Office Action Summary	Application No. 10/810,905	Applicant(s) BU ET AL.	
	Examiner Jarrett J. Stark	Art Unit 2823

DETAILED ACTION

Claims 1–10 and 19 -20 are rejected under 35 U.S.C. 103(a) as being unpatentable over Wieczorek et al. (US 2004/0061228 A1) in view of Chen et al. (US 2005/0136583 A1).

FIG.2e

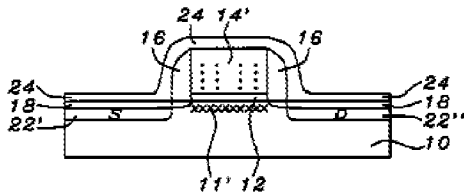
forming lightly-doped extension regions in the semiconductor substrate adjacent each gate stack (Wieczorek et al., Fig. 2d – [205]);

forming a layer of insulating material in contact with a total exposed surface of the lightly-doped extension regions (Wieczorek et al., Fig. 2d – [209]);

forming an interfacial layer of nitrogen within the total exposed surface of the lightly-doped extension regions (Wieczorek et al., Fig. 2e);

forming source and drain regions in the semiconductor substrate adjacent to each of the gate stacks (Wieczorek et al., Fig. 2d – [204]);

FIG. 3

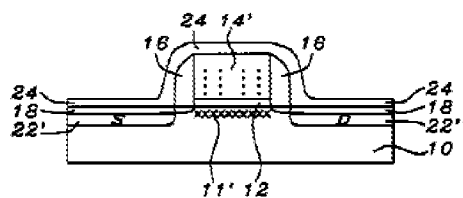
forming a capping layer of contiguous silicon nitride having a thickness in the range of about 200-1000 angstroms over the semiconductor substrate; (Chen, Fig. 3 - [24] and paragraph [0048]).);

annealing, after the formation of the capping layer and with the capping layer in place, the extension regions and the source and drain regions at a temperature in the

range of 1000-1100 degrees centigrade for a period in the range of less than about 10 seconds (Chen, Fig. 4 - [27] paragraph [0051]); and
